Westinghouse Electric Corporation

NS-TMA-1999

Reference: Westinghouse ECCS Evaluation Model, February 1978 Version
WCAP-9220, February 1978

Subject: Behavior of Rod 5G in FLECHT Low Flooding Rate Test Series

FIGURE 1

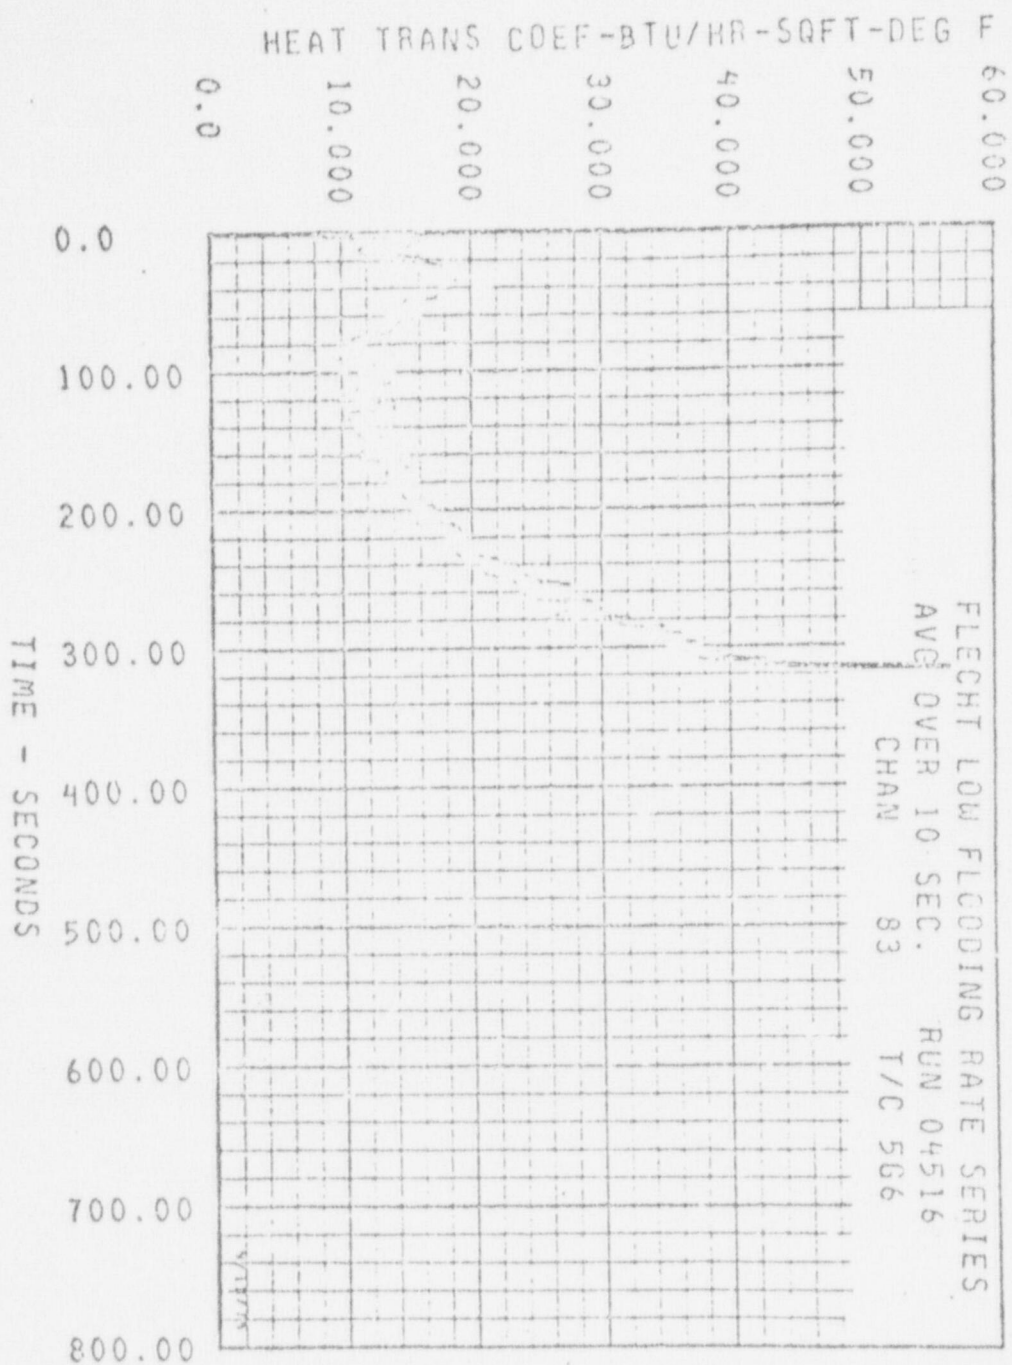
] The behavior of thermocouple 5G-6 ft. was also examined for those tests in which 5G-6 ft. showed the highest heat transfer data. Heat transfer plots of all instrumented rods at the six foot elevation were displayed

[The 5G- 6 ft. data from low flooding rate test 04516 is shown in Figure 1. The high initial film coefficient and large heat transfer between 0-100 seconds are
